**DAVID PLUMMER & ASSOCIATES**

June 3, 2015

**Re: Mediterranean Village Review - #14153**  
**Traffic Impact Study, Parking Analysis & Valet Operations Analysis**

VEHICULAR CIRCULATION HOTEL DROP-OFF - OPTION #2 “OWNER’S RECOMMENDATION”

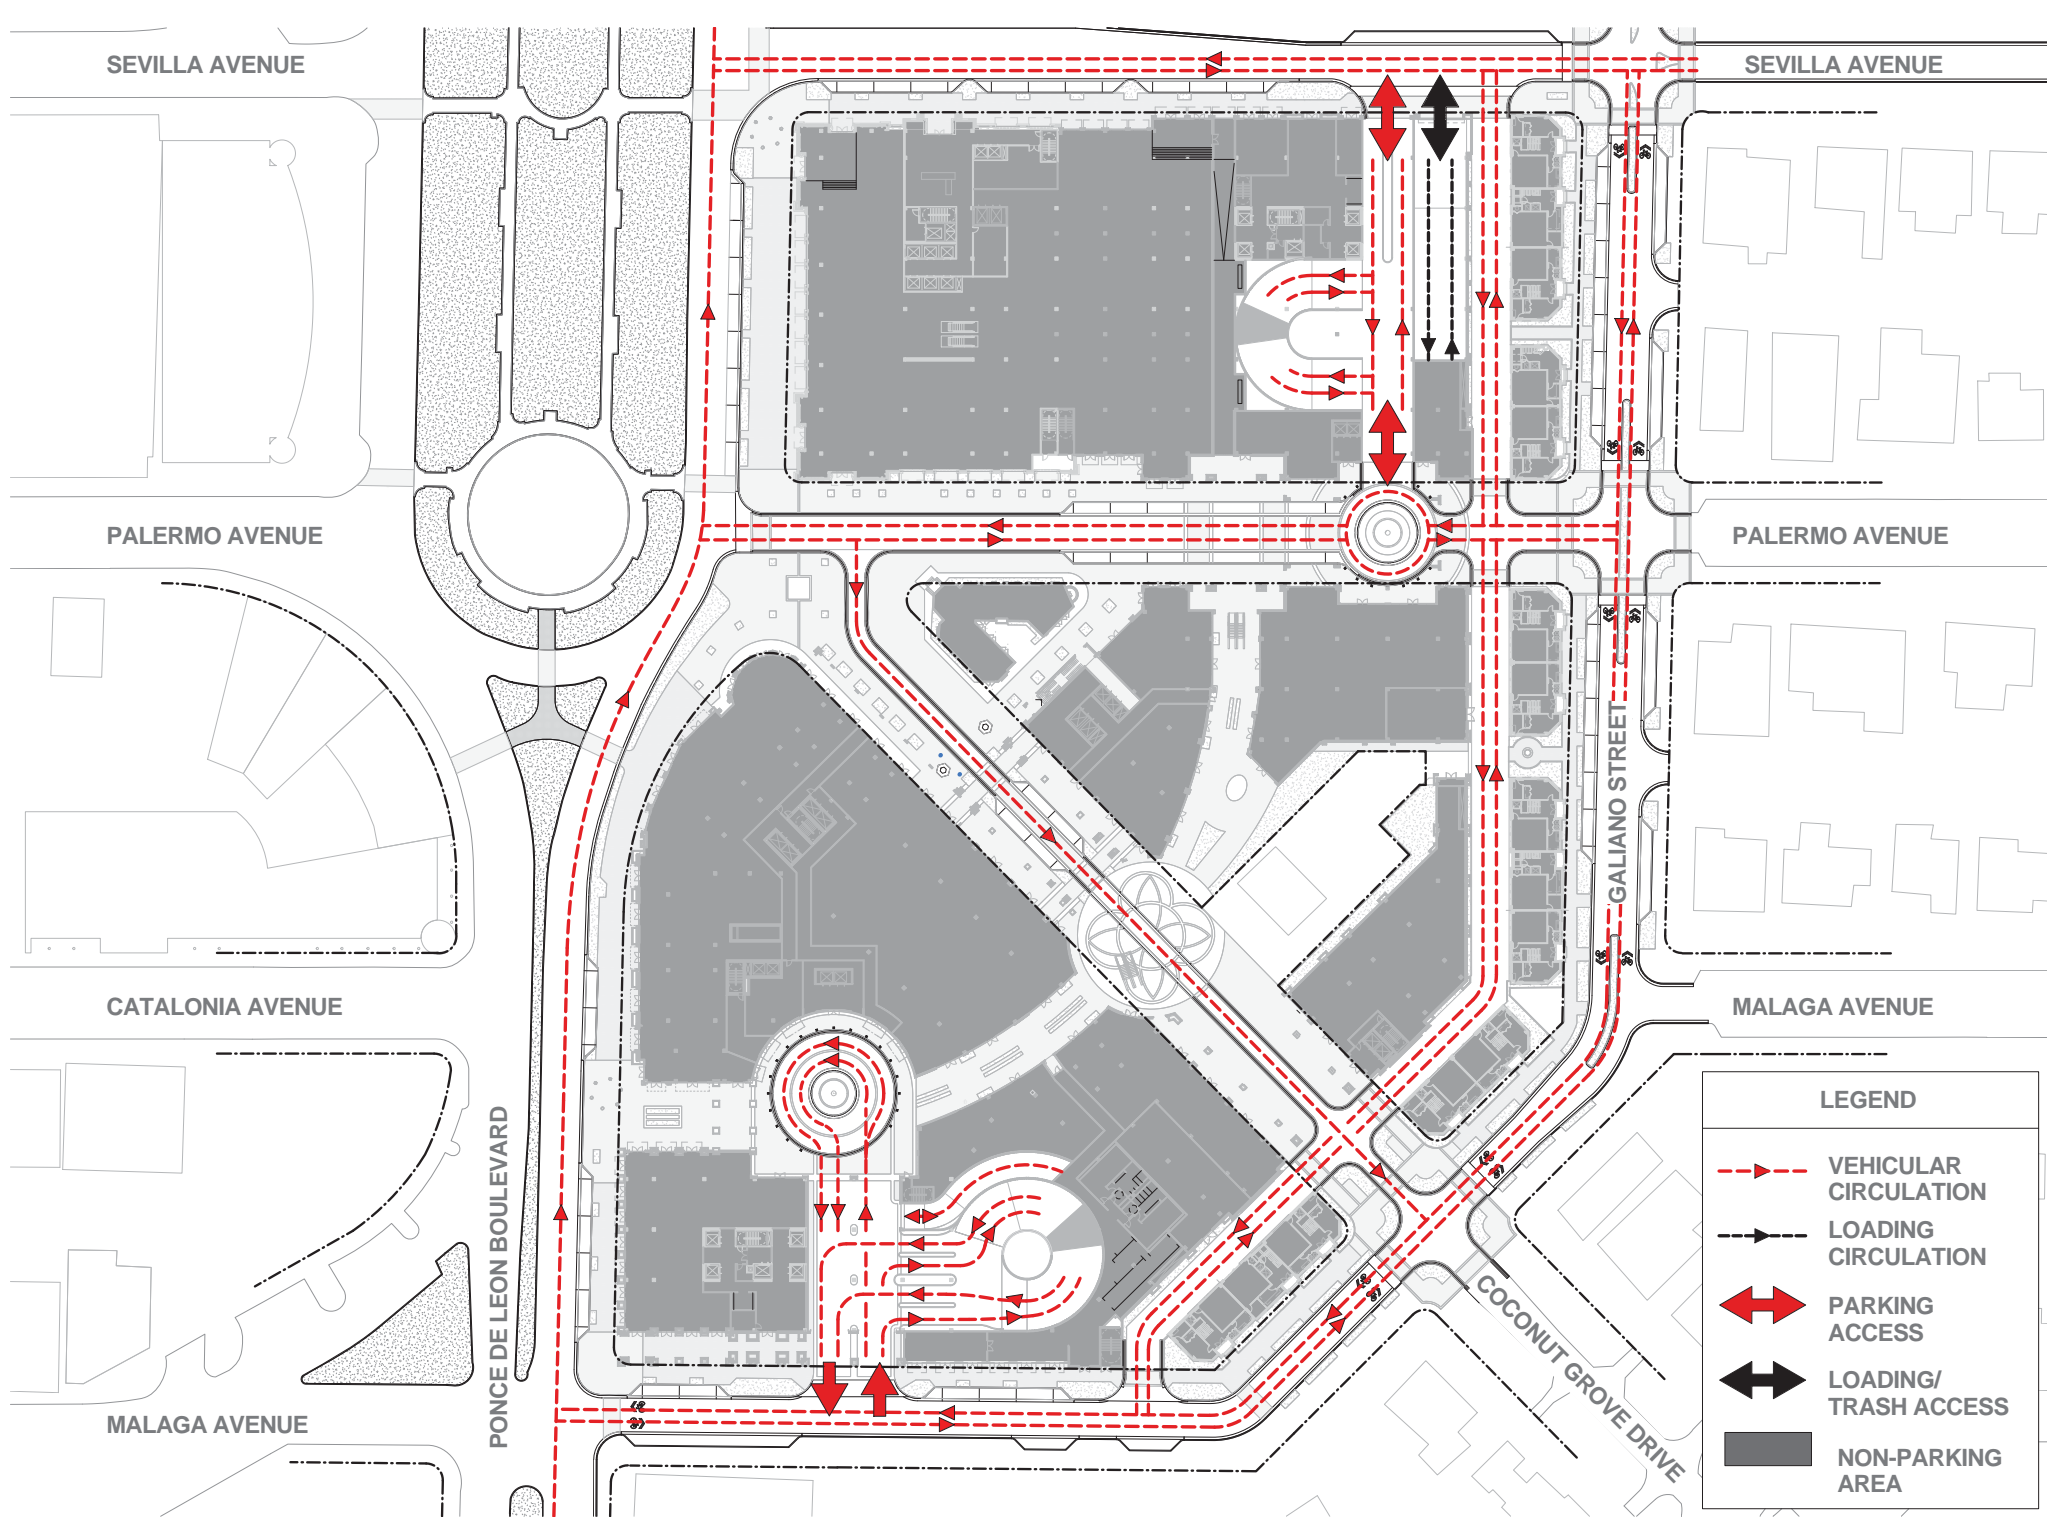
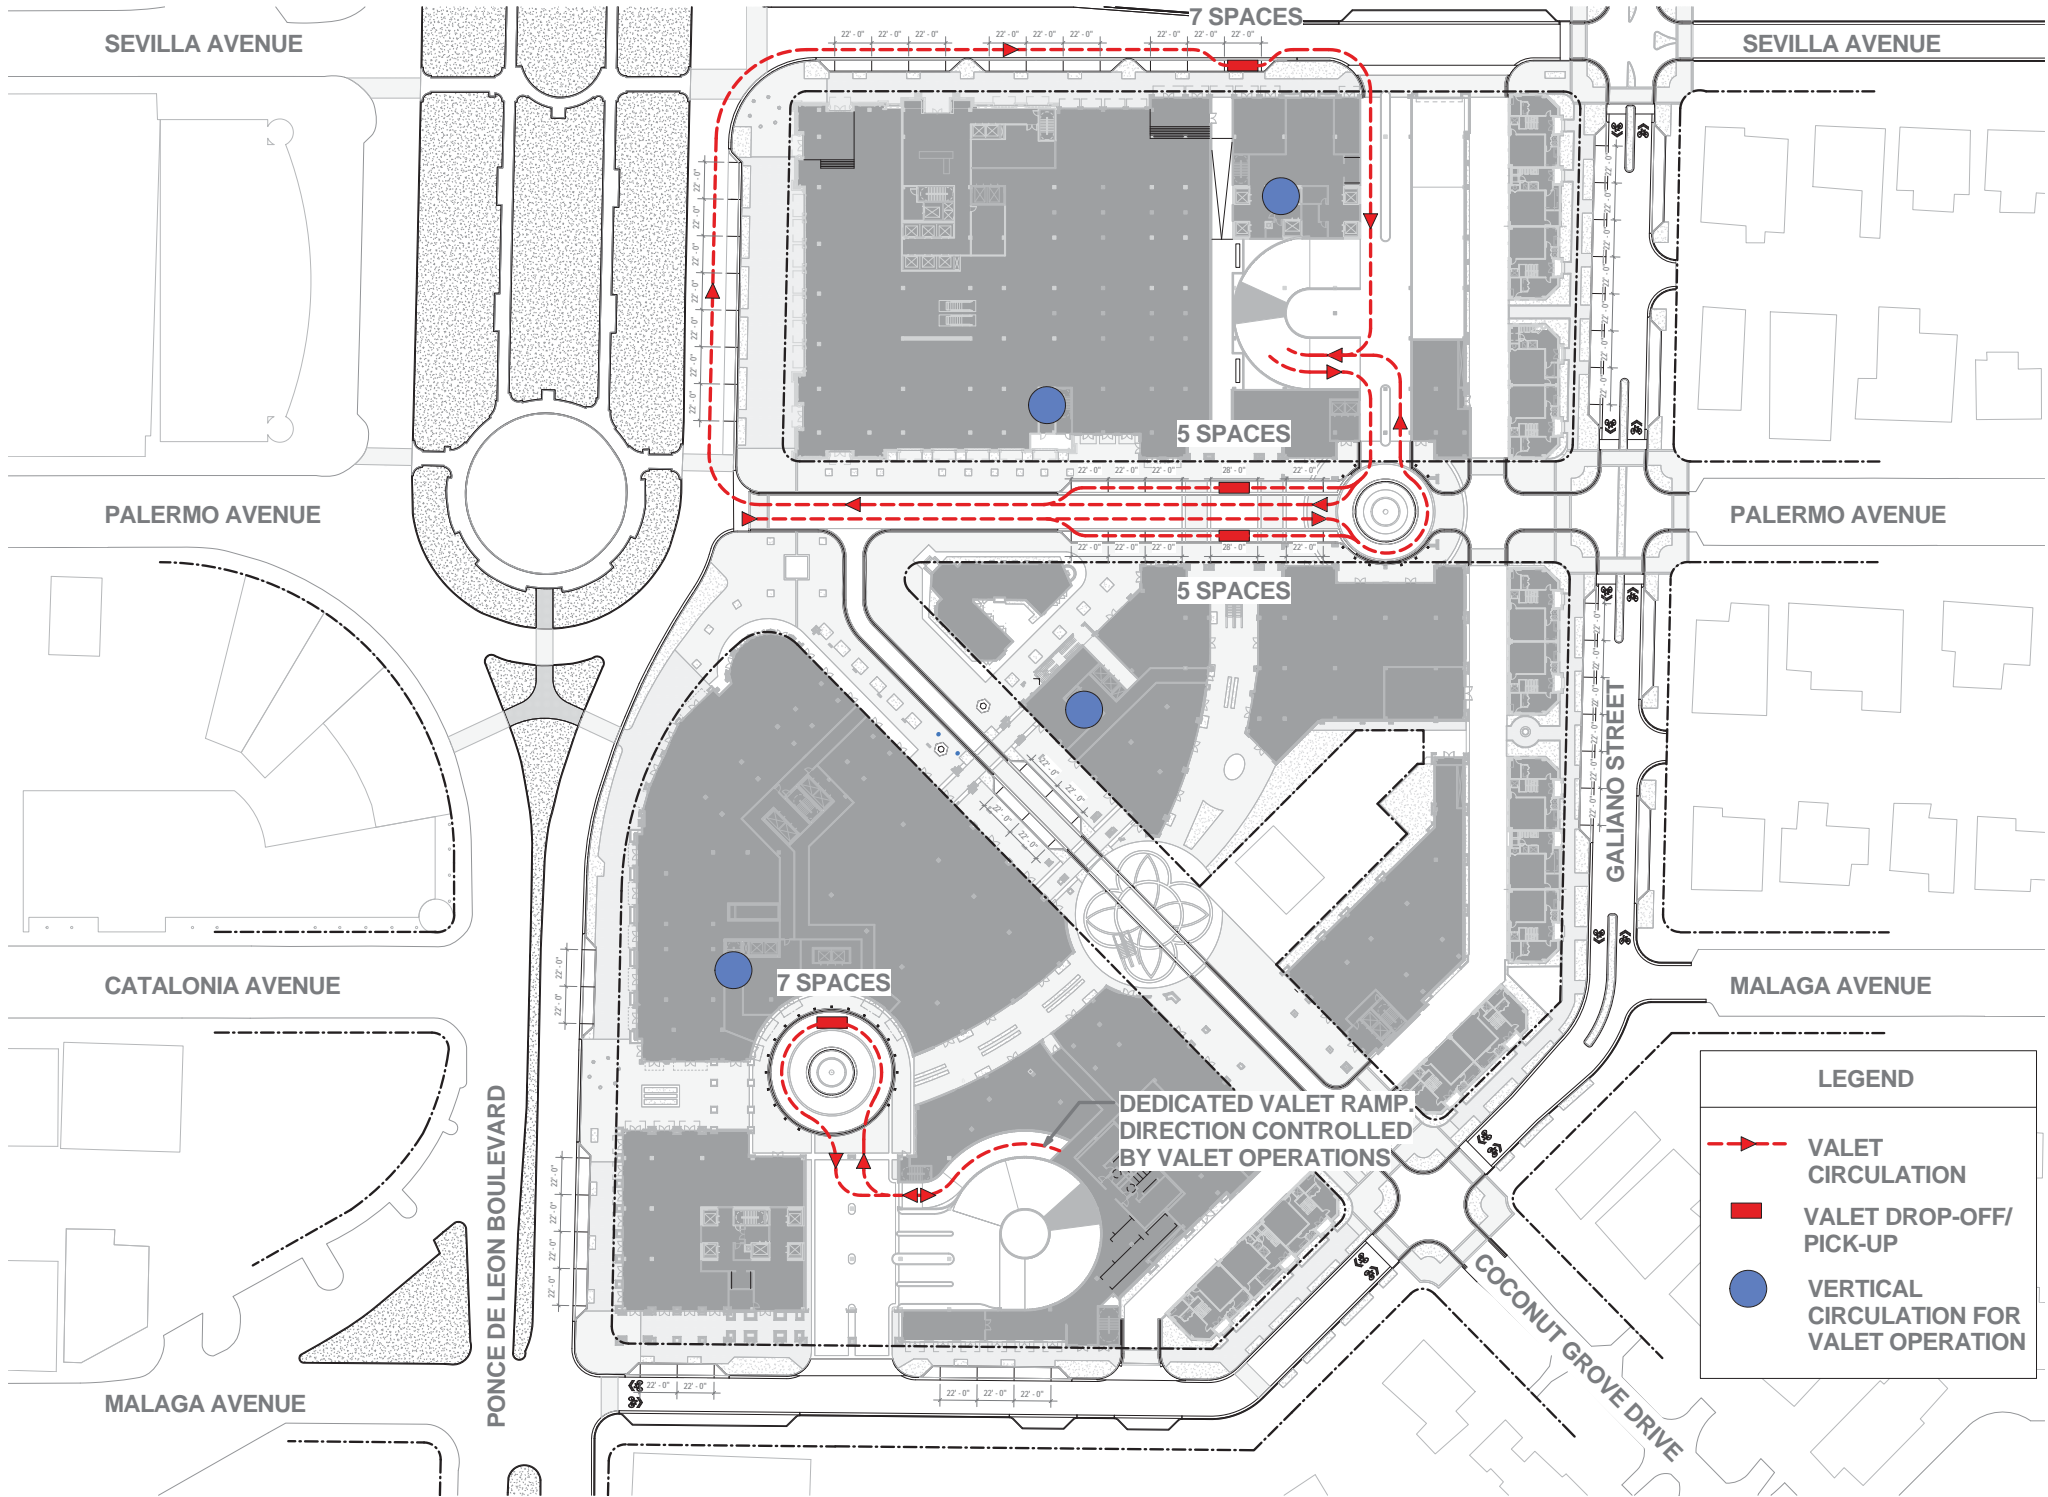
During first reading, the project included direct access to the hotel from Ponce. This access plan for the hotel was acceptable. The project has since changed to address comments from the Commission. Of the newly proposed options, Option 3 is an acceptable alternative and preferable to Option 2 provided that the following conditions are included: 1) the hotel valet ramps will be completely segregated from the Malaga driveway ramping system and no traffic from Malaga would be allowed to access the hotel's porte cochere, and 2) two one-way ramps (similar to the Ponce alternative) or a two-way, two-lane ramp for hotel valet use only is provided. See attachments for hotel access options.
